Work Order ID 129102

Item Name: Baggage Compartment Protector - Floor And Wall

DART SERVICE INSTRUCTION

TO AMEND INSTALLATION INSTRUCTIONS IIN-D407-781-2 REV. A OR LATER APPROVED REVISION
AND INSTRUCTIONS FOR CONTINUED AIRWORTHINESS ICA-D407-781 REV. 3 OR LATER REVISION

**FIGURE 1 - D3879-1 BAGGAGE COMPARTMENT WALL
PROTECTOR - ALTERNATE INSTALLATION**

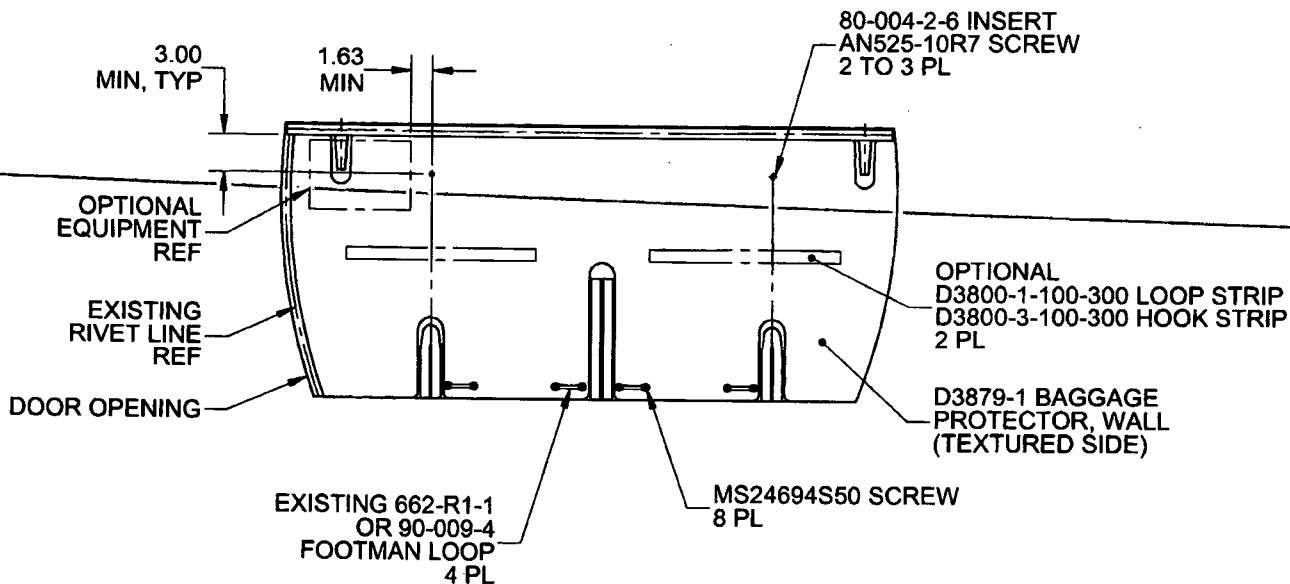
In some aircraft, the top portion of the D206-781-041 Baggage Compartment Wall Protector Kit cannot be installed as indicated in IIN-D407-781-2. The purpose of this DSI is to provide an alternate mounting method to fasten the top portion of the D206-781-041 Baggage Compartment Wall Protector Kit.

It is acceptable to replace qty(2) D3930-1 Clips with qty(2) 80-004-2-6 Inserts. Locate and mark location of the two attachment holes on the baggage compartment wall as shown in Figure 1 of this service instruction. Install 80-004-2-6 Inserts at the marked locations in accordance with Section 3-2-12 of BHT-206-SRM-1. It is acceptable to trim the wall protectors to accommodate optional equipment or transfer attachment holes to the wall protector and install the optional equipment on top of the wall protector with longer fasteners.

Amend the D206-781-041 Baggage Compartment Wall Protector Kit parts list as follows:

ADD:

Qty -061	Qty -031	Qty -041	Part Number	Description
X			D206-781-061	BAGGAGE COMPARTMENT PROTECTOR KIT (FLOOR AND WALL)
1	X		D206-781-031	BAGGAGE COMPARTMENT FLOOR PROTECTOR KIT
1		X	D206-781-041	BAGGAGE COMPARTMENT WALL PROTECTOR KIT
		2	AN525-10R7	SCREW
		2	80-004-2-6	INSERT
